Bath Clean Air Plan

Bath and North East Somerset Council

Clean Air Zone Boundary Updates

674726.BR.042.FBC-04 | 2

Figure 2-4: First proposed extensions to the CAZ

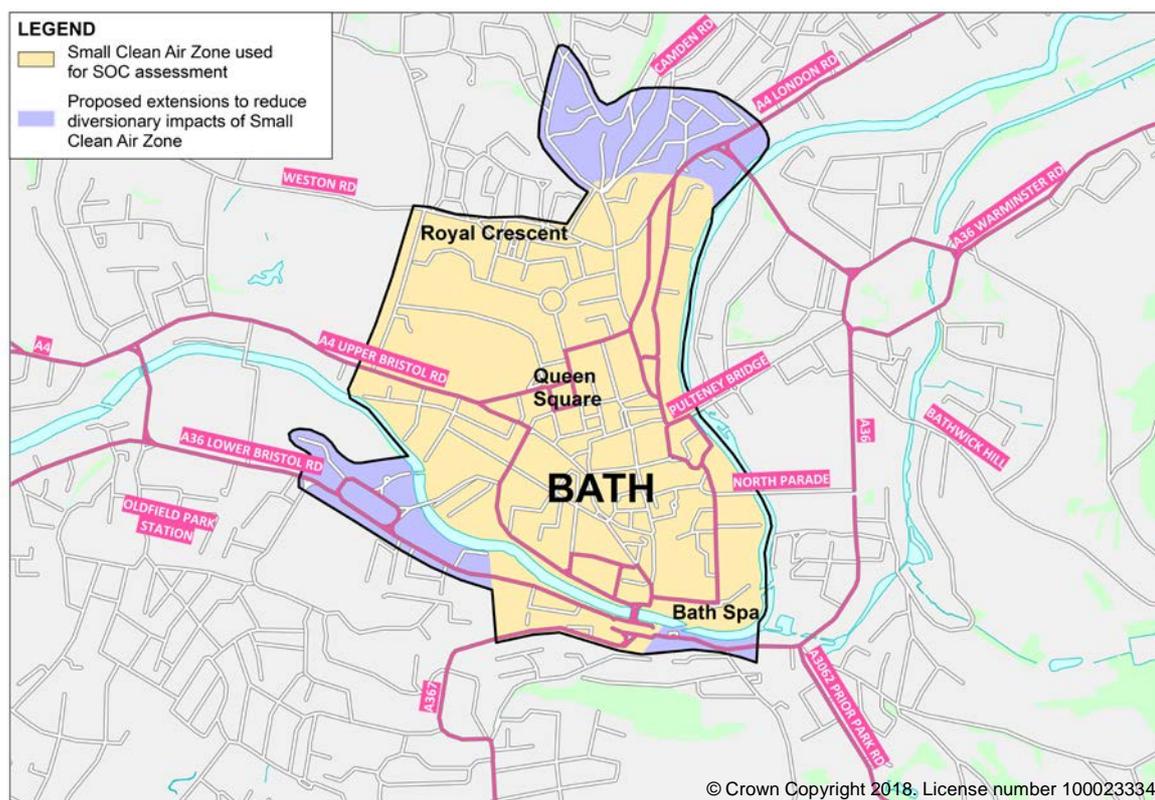
Following an initial assessment and ongoing discussions with key stakeholders within the Council, some amendments to the CAZ were proposed in April 2018. These are shown on **Figure 2-4** above in purple and described below:

- Northwards to St. Stephen's Church (Lansdown Road/Richmond Road junction). Eastwards through Camden Road, Gay's Hill, principally to include the A4 London Road/Cleveland Place junction;
- South East along the A36 Claverton Street to include the junctions with Lyncombe Hill and Widcombe Parade; and
- South West along the A36 Lower Bristol Road to include Pines Way gyratory and the Brougham Hayes junction.

These extensions were primarily focused on preventing the undesirable re-routing of non-compliant vehicle trips around the edges of the zone, which might otherwise result in worsened air quality in these areas and/or undesirable congestion issues.

Figure 2-5: Second proposed extension to the CAZ

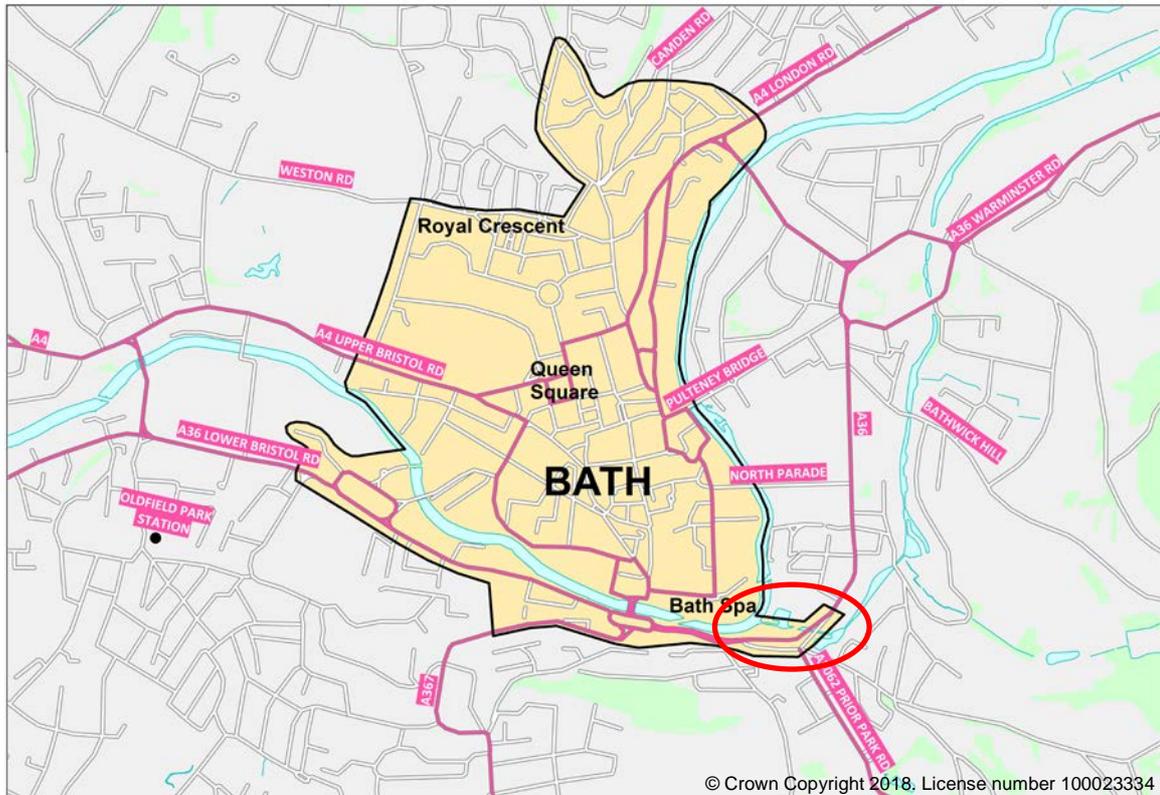
Figure 2-5 shows a further extension, circled in red, which was made to the south east corner of the zone in May 2018. This was to extend coverage to include the A36 Rossiter Road and the gyratory system in Widcombe. The main objective was to include the White Hart junction at the bottom of Widcombe Hill and Prior Park Road, so preventing 'rat-running' or avoidance issues with routing of non-compliant vehicles between these roads and the A36 Pulteney Road. A further issue with not including the White Hart junction was the risk of increased traffic routing between the A36 Pulteney Road and Greenway Lane, using Prior Park Road, Rosemount Lane and Forefield Rise. The latter two roads are narrow residential streets where opportunity for two-way passage is very limited.

Figure 2-6: Third proposed extension to the CAZ

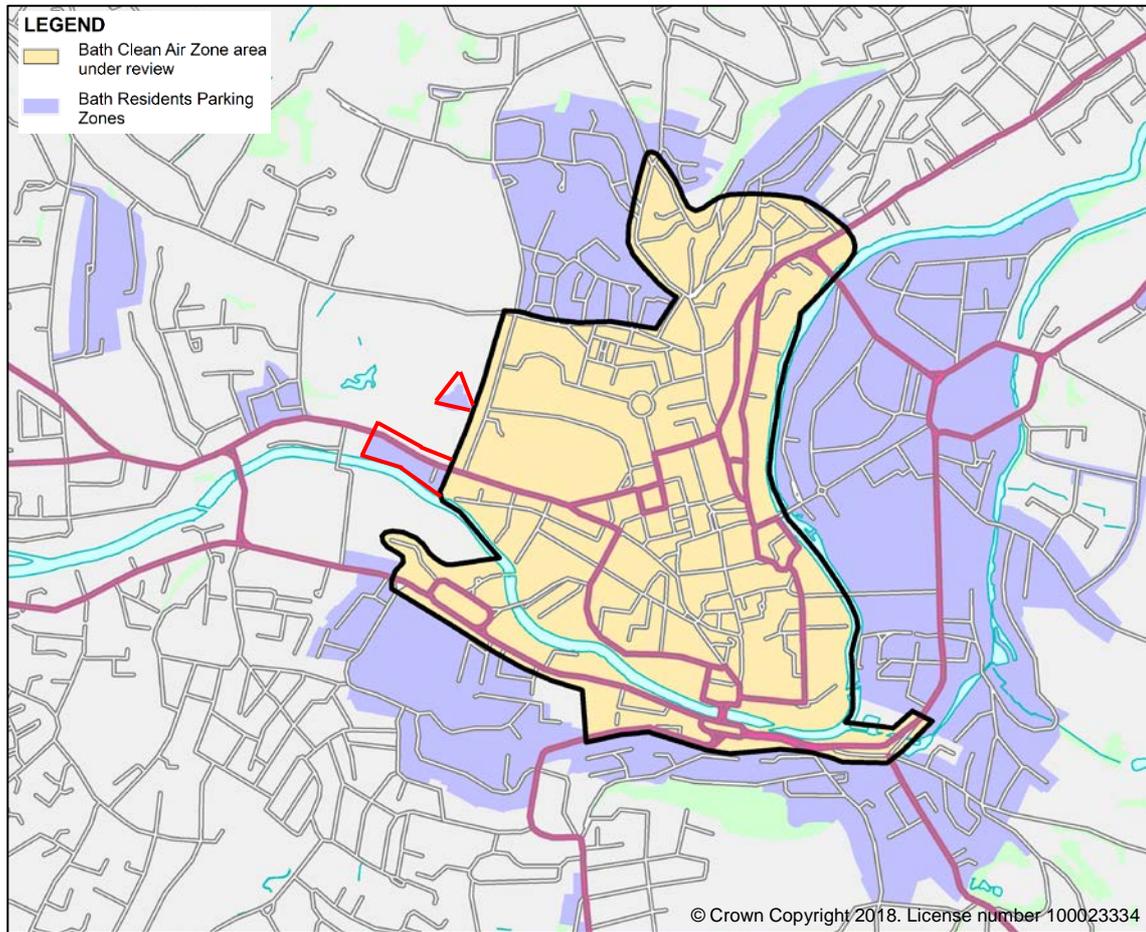
Minor changes to the boundary were again made in June 2018. These are shown by the red lines in **Figure 2-6**, and ensure that the entirety of Residential Parking Zone (RPZ) 6 was within the CAZ boundary. It was considered that if a small part of RPZ 6 remained outside the zone boundary, it could result in parking here being more desirable to residents of RPZ 6, particularly if a large part of the vehicle ownership was non-compliant.

Figure 2-7: Fourth proposed extensions to the CAZ

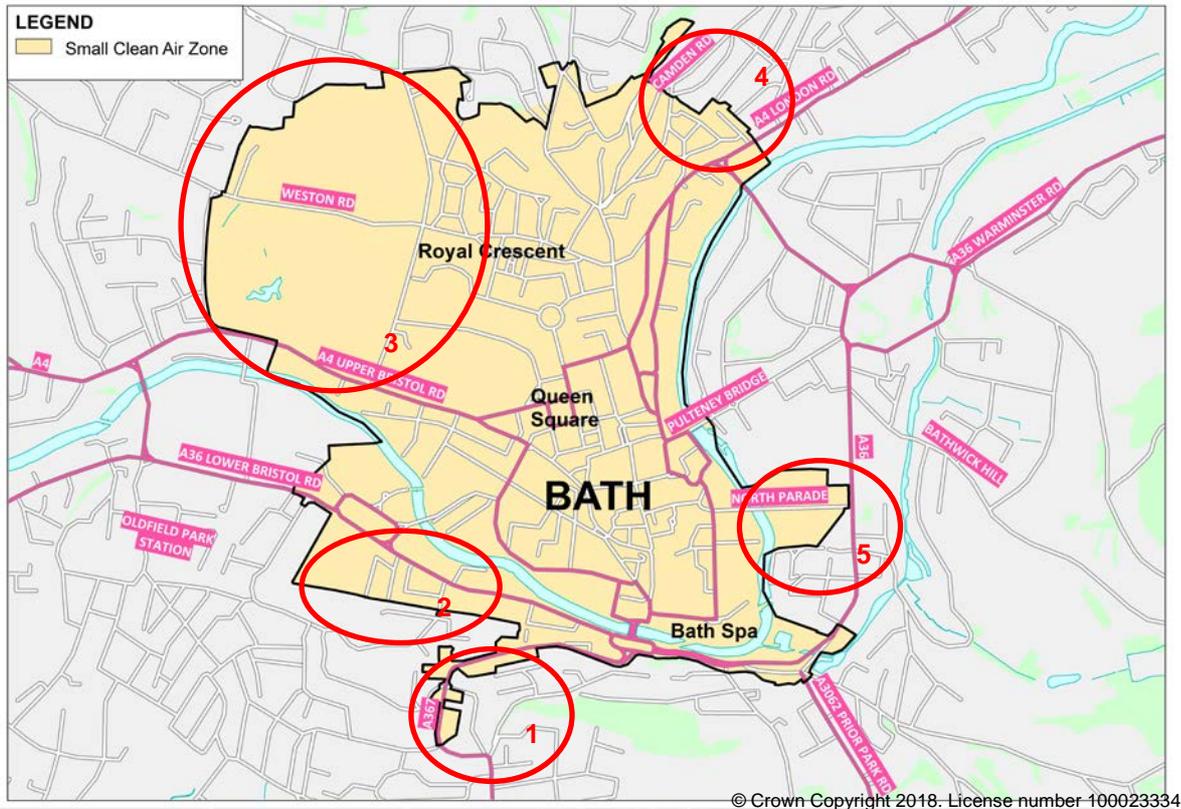
Following a meeting and a walk around the CAZ boundary with B&NES officers, several adjustments to its position and 'detailing' were made. The changes that were agreed upon are highlighted in the red circles and numbered in **Figure 2-7** above. They include the following:

- 1) An extension to the south up the Wells Road (A367) to the junction with Oldfield Road (B3111). This includes new boundary crossing or 'cordon' points on Hayesfield Park and Upper Oldfield Park, whilst the cordon point on the A367 is moved to a point just north of the B3111 Oldfield Road junction.

- This change was proposed by the residents of Upper Oldfield Park to avoid rat-running on what is a minor road, and one which serves as a main point of access to Hayesfield school. The signed position of the CAZ cordon point on the A367 just north of, or effectively at, the junction, means that drivers turning to avoid entry would do so via a 'B' classified road.

- 2) Moved to the south to the railway bridge on Westmoreland Road, with the revised cordon point just north of the junction with Westmoreland Station Road/Lower Oldfield Park/Thornbank Place.

- This change was made as the junction is a clearer and more obvious turn-around point before entering the CAZ. Even HGVs would have the opportunity to turn around here using the entrance area to Westmoreland Station where the carriageway area is quite wide. This change removed the need for two cordon points to/from the A36 Lower Bristol Road at Westmoreland Road and Cheltenham Street, the latter less than ideal;

- 3) Extended to the north west to encompass the entirety of Victoria Park, as well as the whole of the 'St. James Square' area. It was considered this was desirable because of a number of factors as follows.

- The boundary crossing point situated by the Victoria Monument in Victoria Park just west of Marlborough Lane was considered unlikely to be acceptable due to its proximity to the monument;

- The large number of medium-stay (up to 4 hours) parking spaces available in Victoria Park could become more popular if omitted from the zone. This could serve to increasing vehicular traffic in the

park. As the primary CAZ scheme objective is to promote clean air, it was considered that decreasing the quality of the air in a park would be counter intuitive; and

- The initial zone created a lot of boundary crossing points onto Julian Road, with signing/ANPR cameras needed to cover several minor roads. The revision to the boundary meant that this could be reduced and rationalised to only one cordon point at the top of Cavendish Road.

- 4) Small changes to the boundary crossing points on Camden Road and Gay's Hill and an extension to cover a large property on Rivers Road with access 'only' off St. Stephen's Road.

- The change to the boundary crossing points on Camden Road and Gay's Hill were done to make the cordon 'entry' points and signing more visible from the preceding junction, allowing drivers to use the junctions as decision points to avoid entering the zone should they choose; and

- The boundary was extended around the said property in Rivers Road due to its sole vehicular access via the junction with St. Stephen's Road, which was already inside the zone.

- 5) Adjusted east to the end of North Parade Road.
- This eastward movement of the boundary crossing point on North Parade Road to the junction with the A36 Pulteney Road was proposed to avoid 'entrapment' of drivers making the turn into North Parade. This is because, once such turns are executed, there was considered to be no viable means of a non-compliant vehicle taking action to avoid zone entry. Whilst turning within the Sports Centre or Cricket Ground car parks would be possible to execute a 'U' turn, this was hardly considered ideal.

Figure 2-8: Fifth proposed extensions to the CAZ

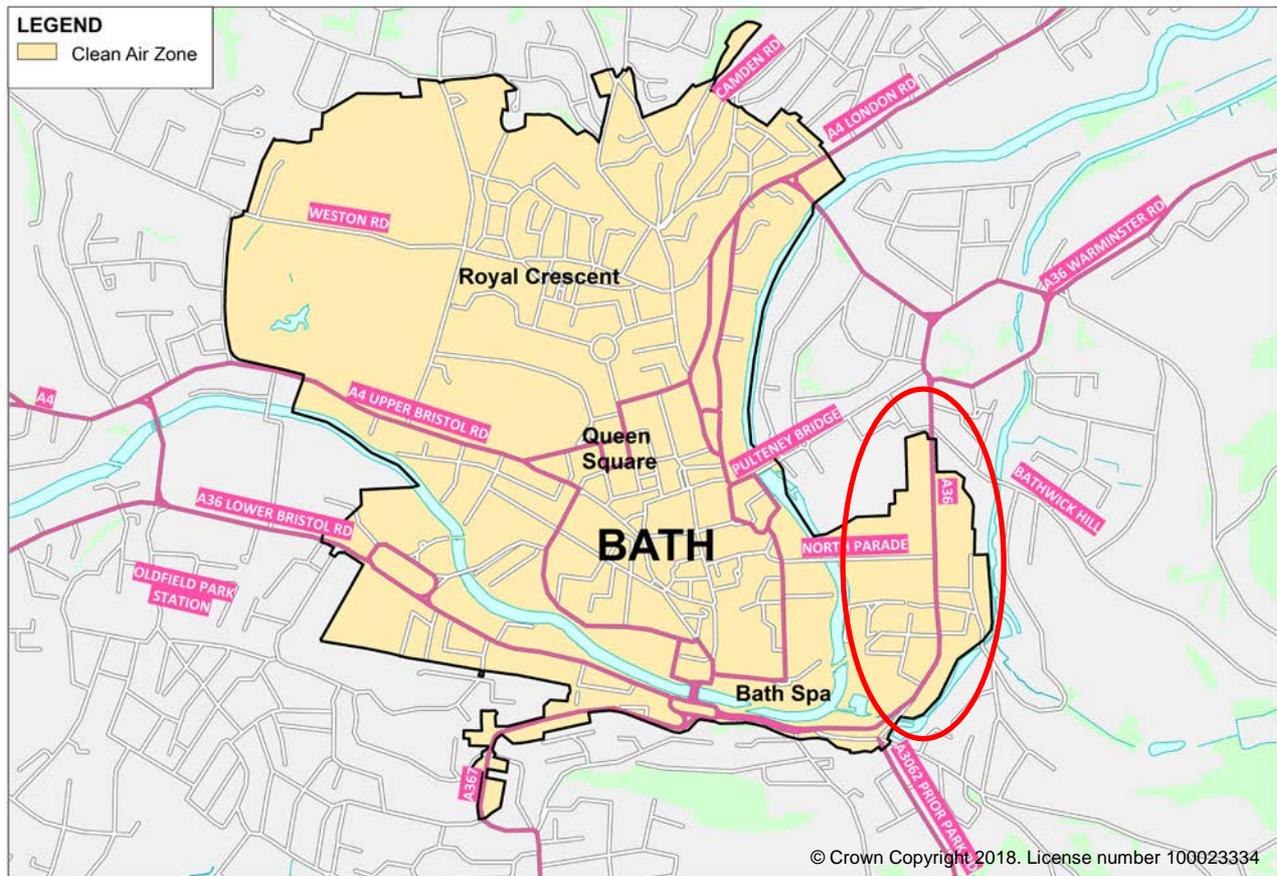
Following a meeting with cabinet the CAZ was further extended in the Widcombe area, as circled in red on **Figure 2-8** above.

The CAZ boundary has been extended to capture the entirety of the A36 Pulteney Road, Pulteney Gardens, The Bath Hotel and Widcombe C of E primary school. The boundary line now cutting off at the Bathwick Hill Roundabout to the north and following the canal to the east. This has resulted in the moving of two boundary crossing points in the area; one from the east end of North Parade to the southbound A36 exit from Bathwick Hill Roundabout, and the other from Pulteney Road to where Pulteney Gardens crosses the canal.

The reason behind the boundary extension was the potential for 'entrapment' and vehicle avoidance impacts on the now included residential streets. A 'key' issue was the likely impact on Widcombe C of E Primary School, with minor streets around the school offering the most obvious turning around or 'U' turn opportunity for a non-compliant vehicle driver when approaching the original cordon point just north of the Bath Hotel junction. An HGV reaching this point would have no real alternative to crossing the CAZ boundary. The new boundary addresses this operational risk by moving the cordon point on the southbound A36 to the exit point from Bathwick Roundabout. This would allow drivers seeking to avoid entry (including HGV drivers) to use either Bathwick Hill, Vane Street, or make a 'U' turn at the roundabout back to Sydney Place.

Figure 2-9: Sixth proposed amendments to the CAZ

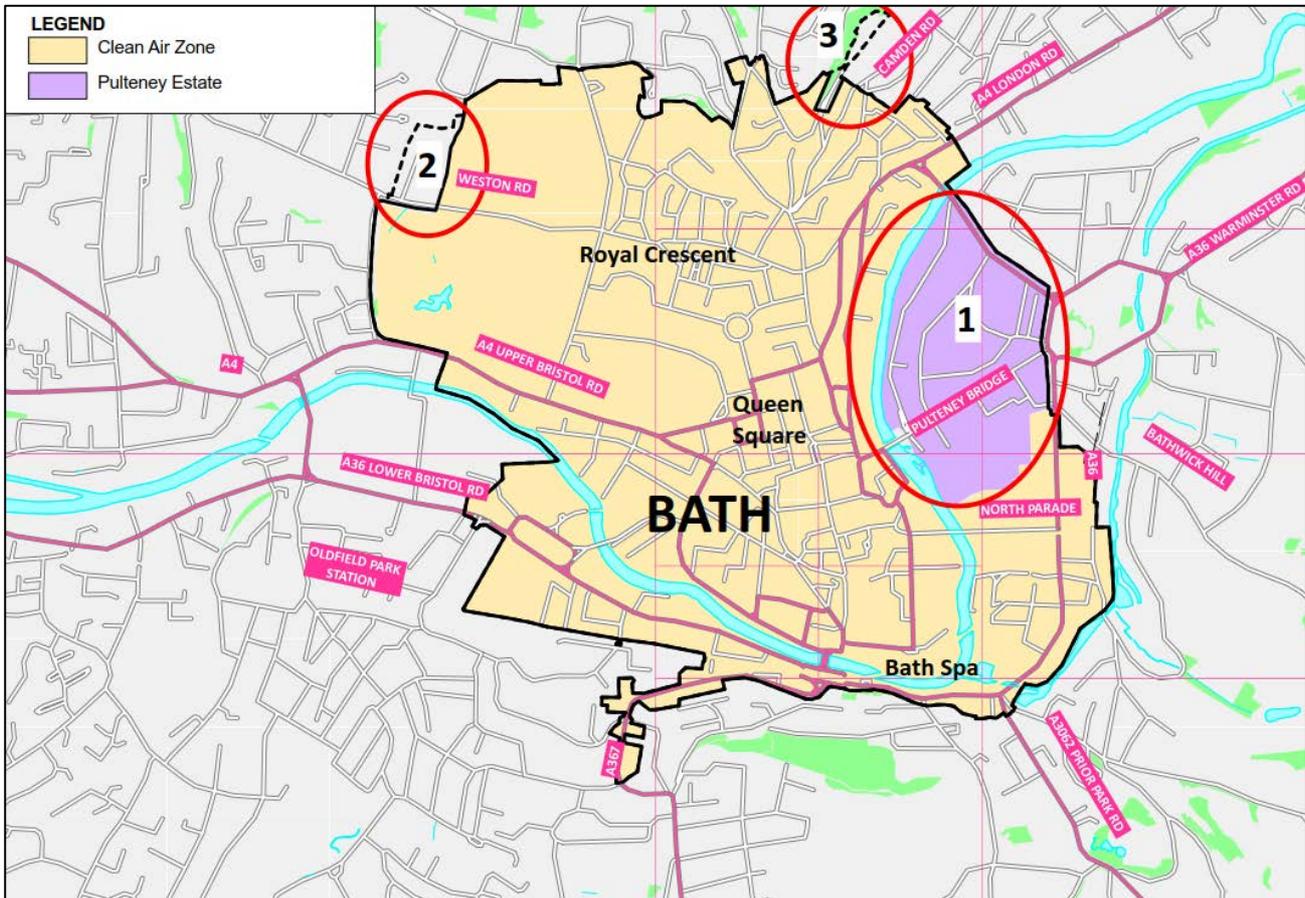
Following the consultation period, three alterations to the CAZ boundary were proposed, with a new area being included and two areas being removed. These are shown in **Figure 2-9** above and described below:

- 1) Inclusion of the Pulteney Estate including Bathwick Street but excluding the A36 around Sydney Gardens.
 - During the consultation period there were concerns from residents in the Pulteney and Bathwick Estate about an increase in idling coaches, rat-running traffic and drop-offs or parking of non-compliant vehicles in the area, as it was very close to the city centre.

- Including this area only and leaving the A36 outside the zone, allows for suitable 'turn-back' options for large vehicles via the Sydney Gardens 'loop' (Beckford Road/Sydney Place/Sydney Road) or a 'U' turn at Bathwick Roundabout. If the A36 to the North Road junction had been included in the zone, large vehicles could become entrapped as they would have no option to avoid entering the CAZ. Light vehicle traffic may also have increased on North Road, outside of King Edwards School.

- 2) Removal of Cranhill Road to the west of the zone.
 - During the consultation, several people requested the removal on Cranhill Road from the zone as it was a cul-de-sac and therefore, not subject to much traffic. Cranhill Nursing Home would also be inside the zone, causing issue with carers, visitors and deliveries. Removing the nursing home would alleviate these issues.

- Removing Cranhill Road increases the risk that vehicles may turn around in it to avoid the CAZ, however, this is considered low risk.
- 3) Removal of Rivers Road and Beacon Wood House from the north part of the zone.

- Rivers Road is a private road which leads only to a Beacons Wood House, a private property which also has access from Perfect View and, therefore, doesn't need to be inside the zone.
